**Calvert Cliffs  
Nuclear Power Plant**

**SUBJECT:** Calvert Cliffs Nuclear Power Plant  
Unit Nos. 1 & 2; Docket Nos. 50-317 & 50-318  
License Amendment Request: Safety Injection Tank Verification Frequency

FIGURE 1

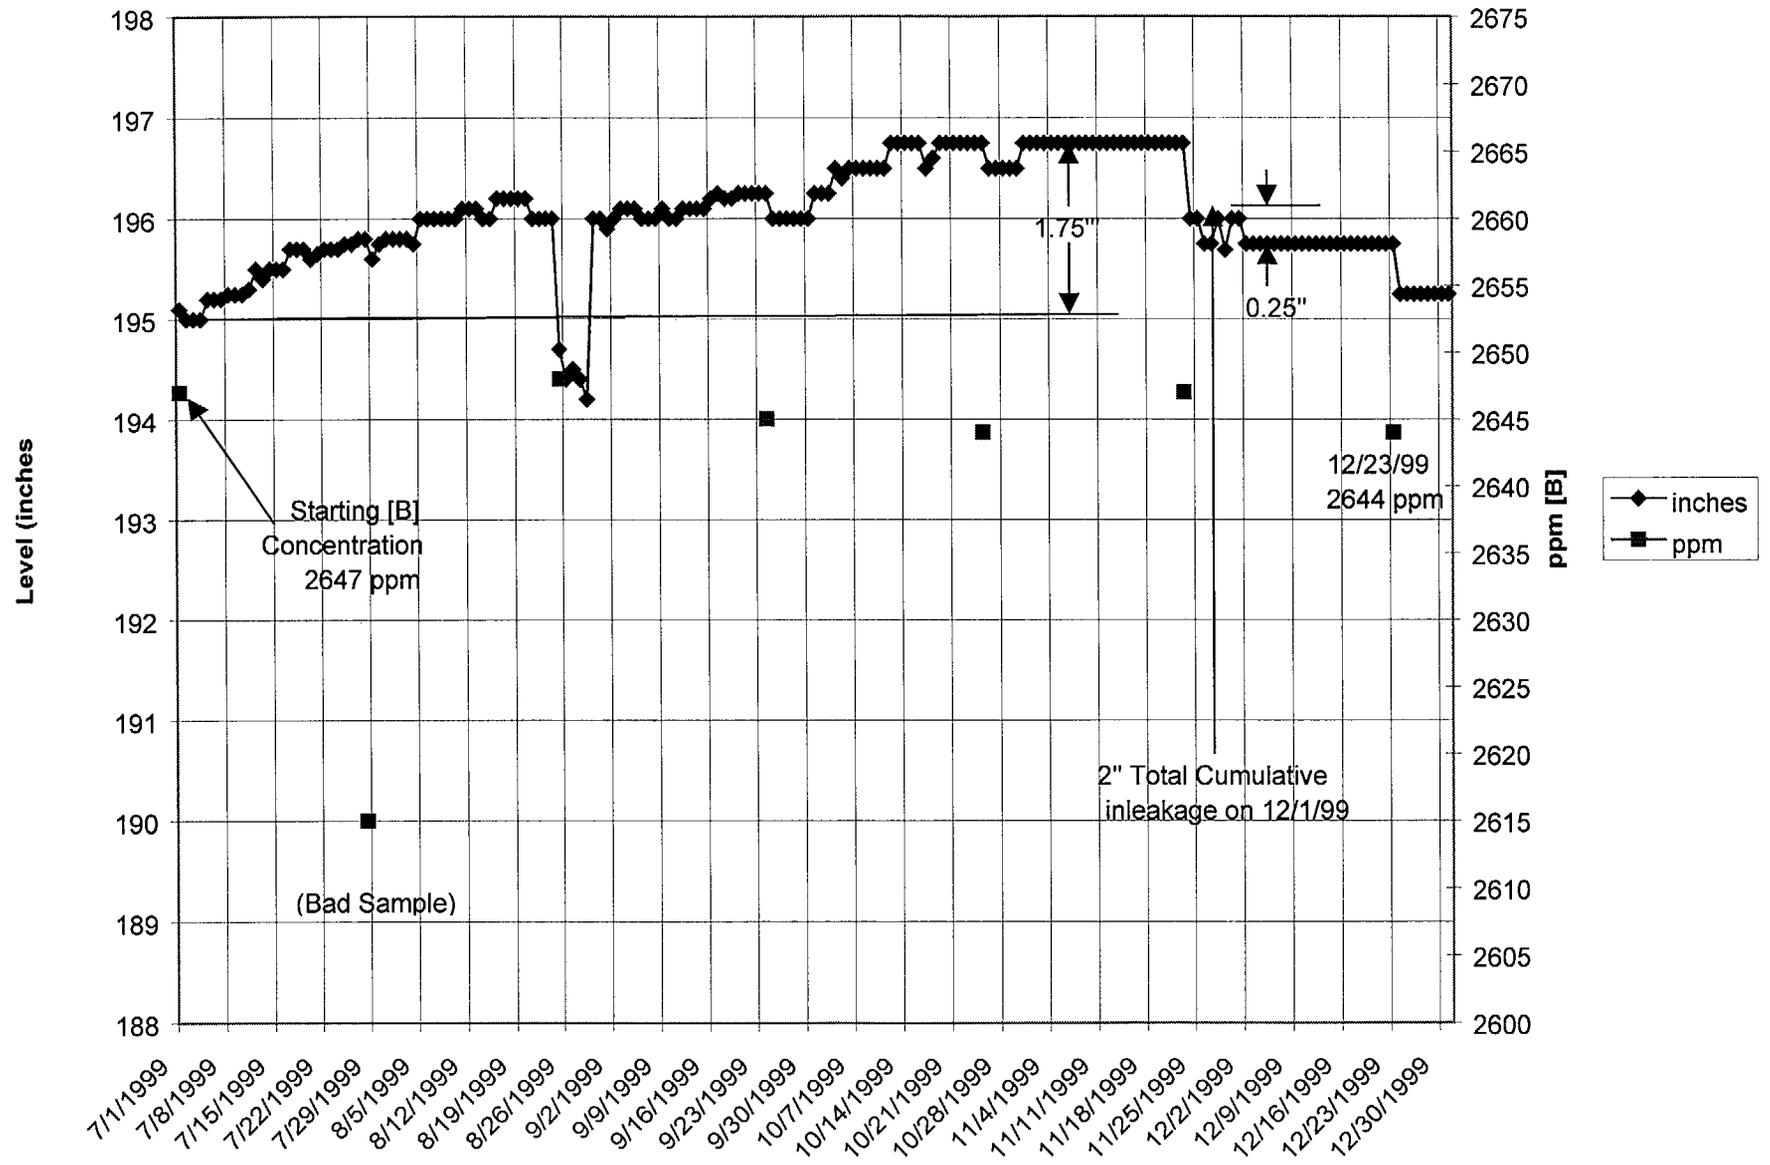
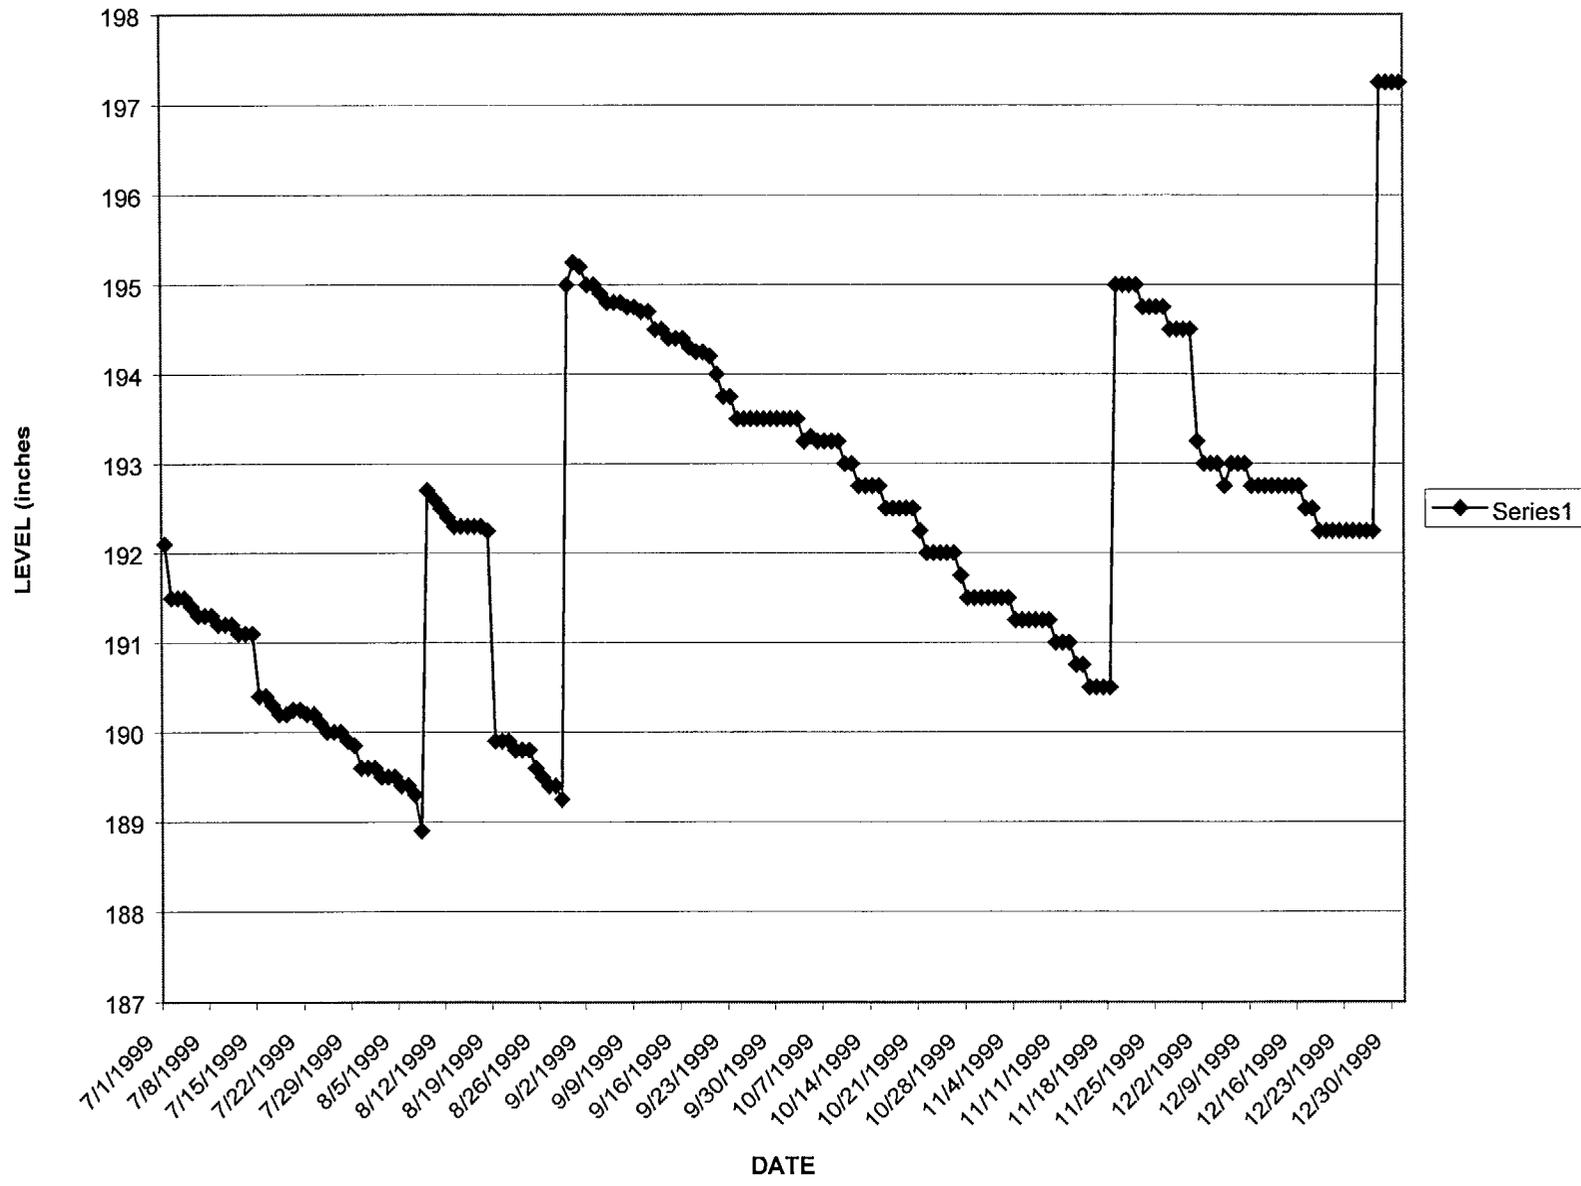
If we trend increases in SIT level then it is important to have the ability to differentiate between inleakage and level replenishment. This is made easier when the SIT levels are trended and graphed over time. Inleakage shows up as a gradual increase and SIT additions show up as a step change. Examples are given in Figures 1 and 2.
